**ADDENDUM
NO. 1**

March 3, 2021

Scott County School District 1 – Austin Elementary Additions & Renovations and HS Pool Renovation
Austin, IN 47102

ADDENDUM NO. ONE

DETAIL 904 - TEMPORARY INLET PROTECTION/FILTER SOCK DETAIL
NOT TO SCALE

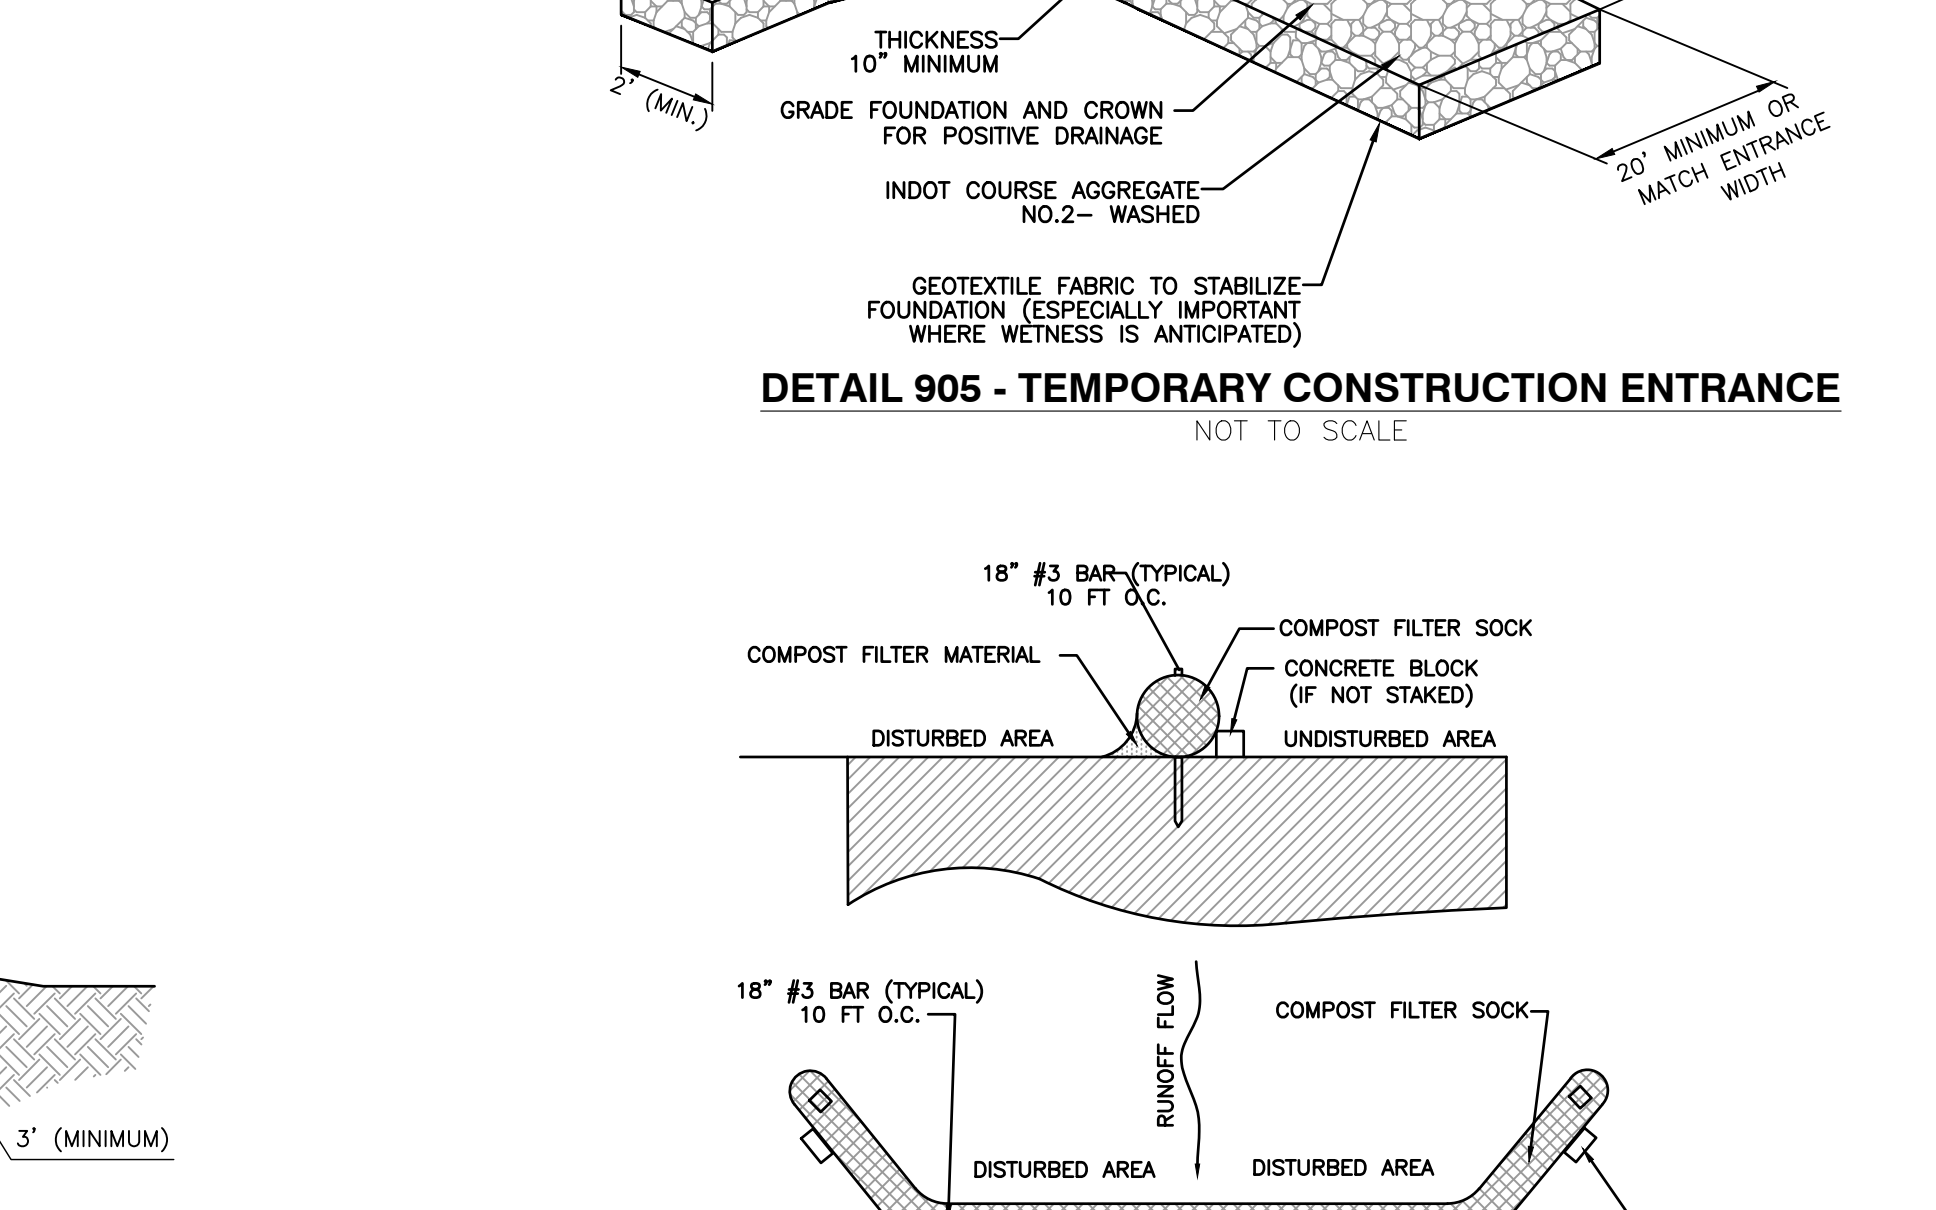
Added Rip Rap apron to Structure 416 end section

Revised Detail 903 table to show correct Structure numbers, added information for Structure 416, and revised depth information for Structure 400

FIRST FLOOR DEMOLITION PLAN - UNIT C AES

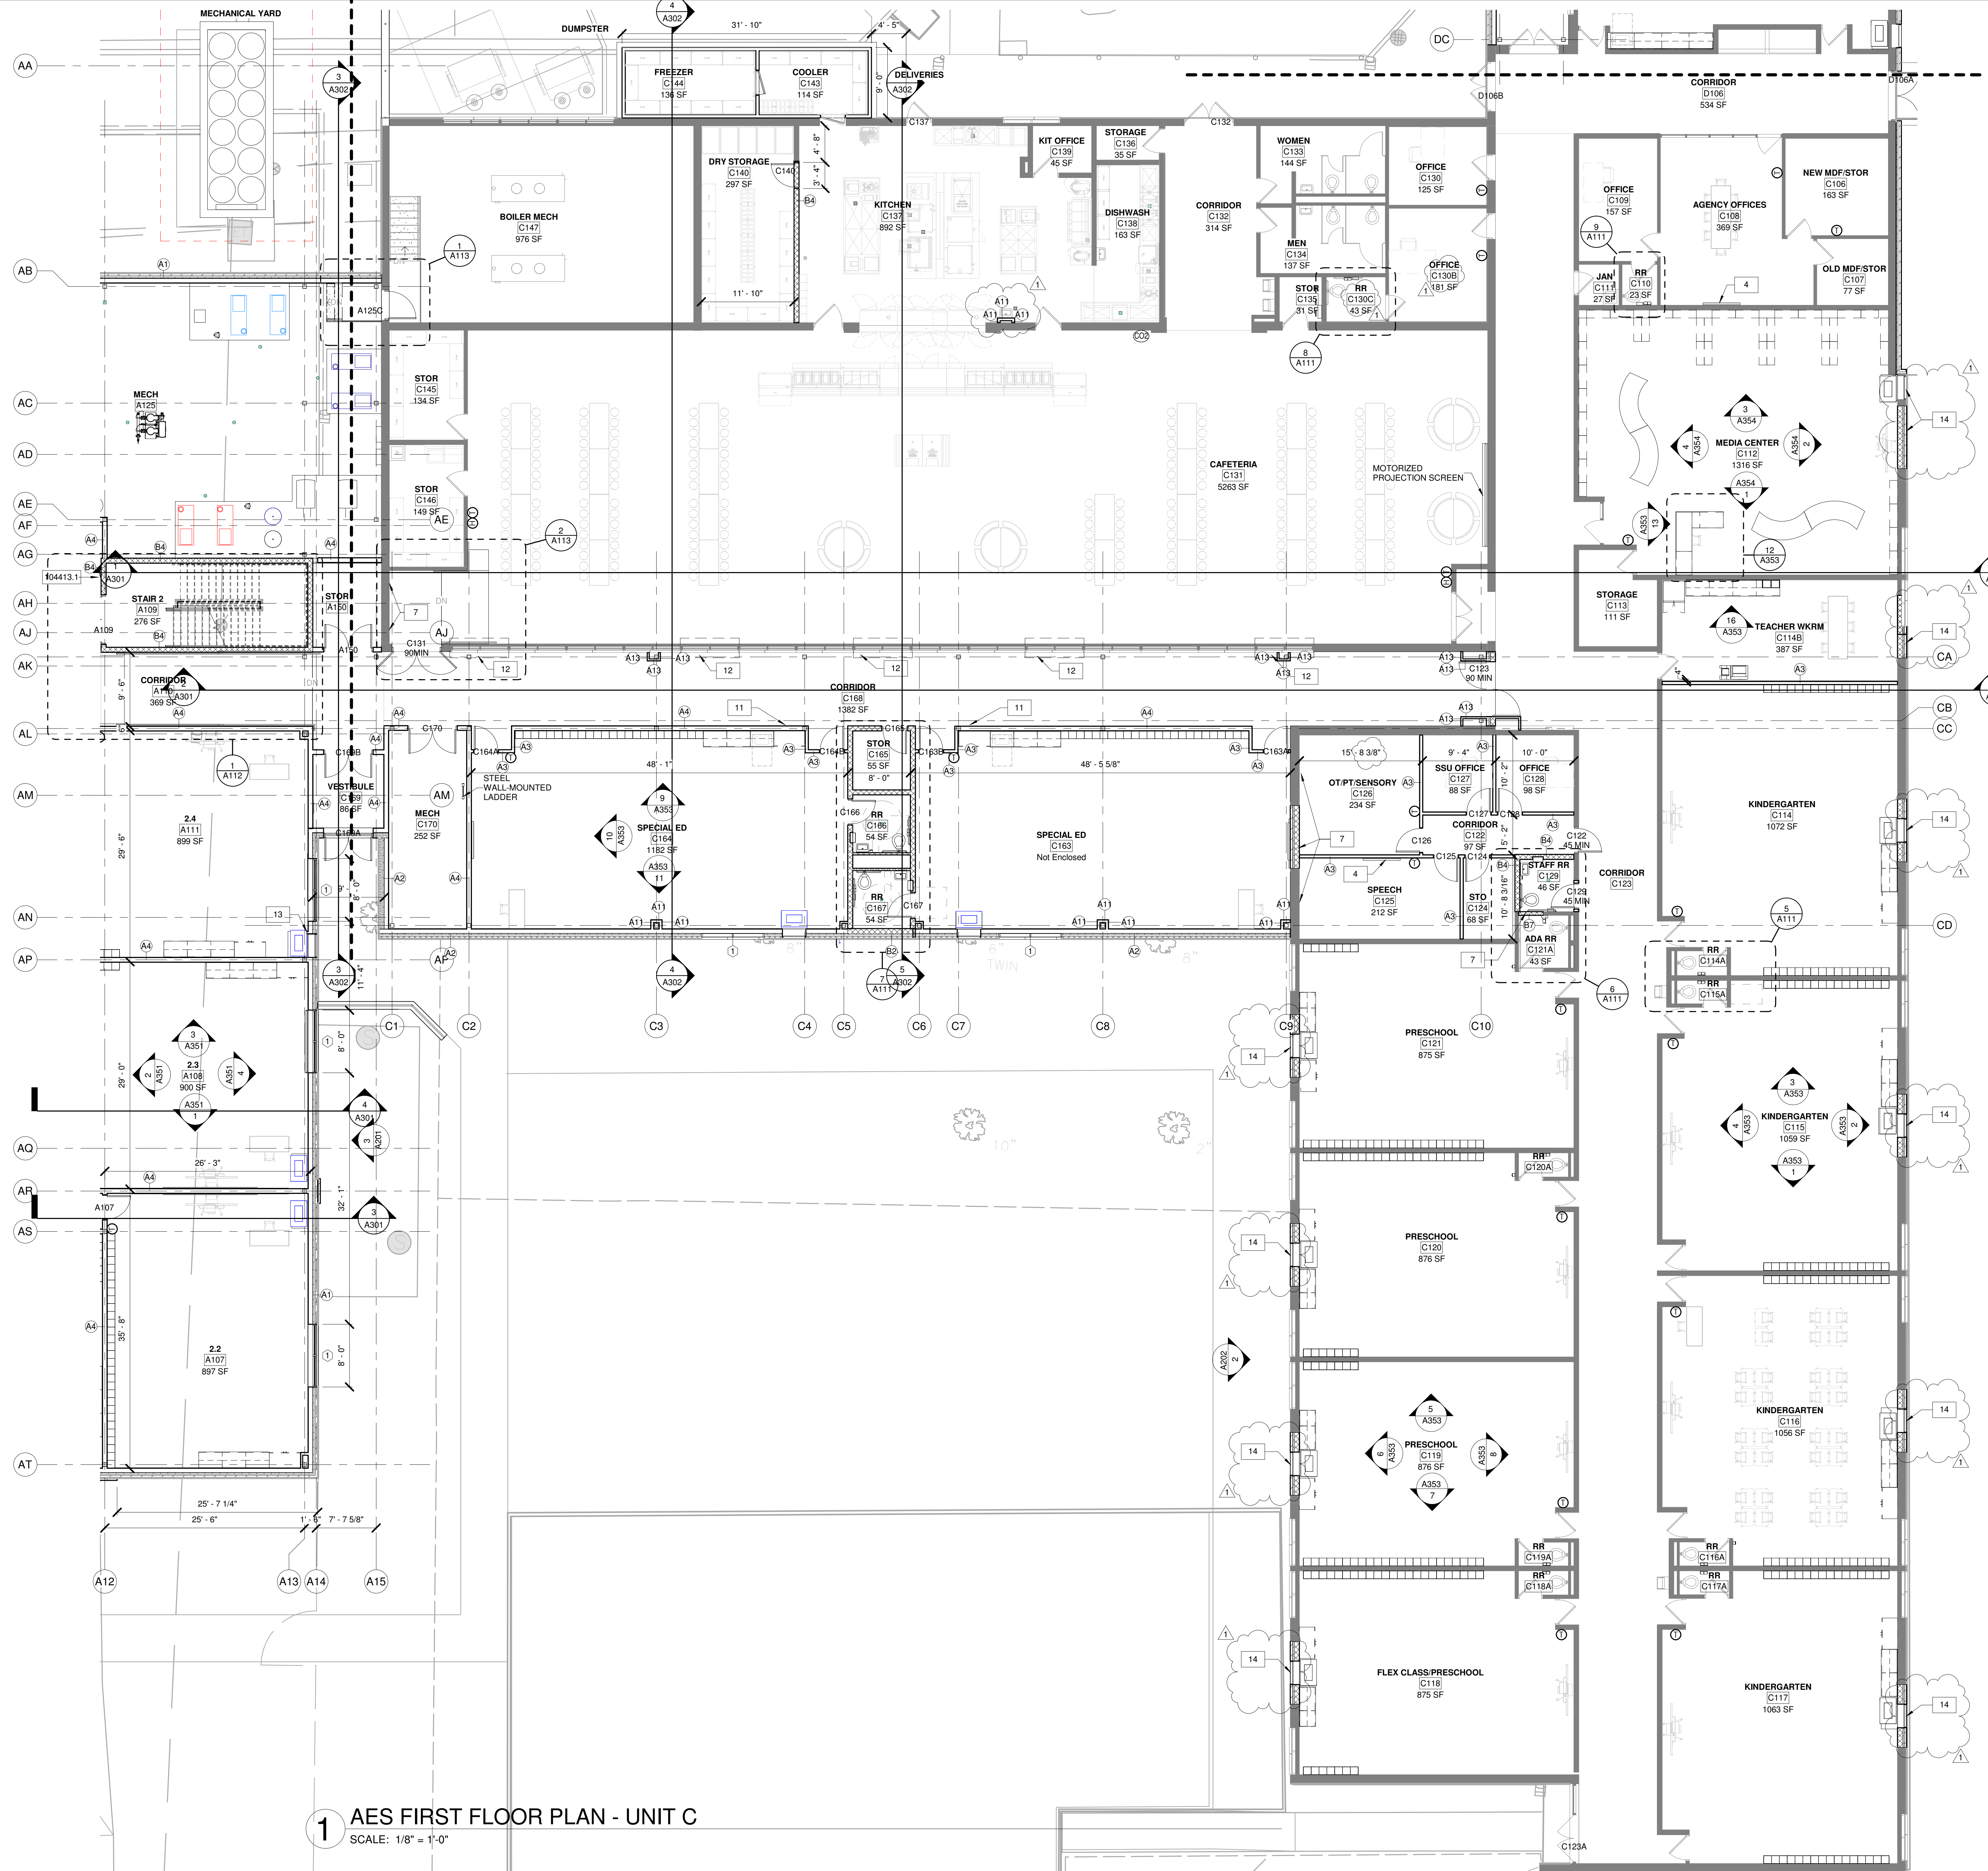
3. Drawing No.: AD101C
Drawing Sheet Title: FIRST FLOOR DEMOLITION PLAN – UNIT C AES
Revision:
Updated plan with mechanical unit grill demolition information. See revised sheet attached.
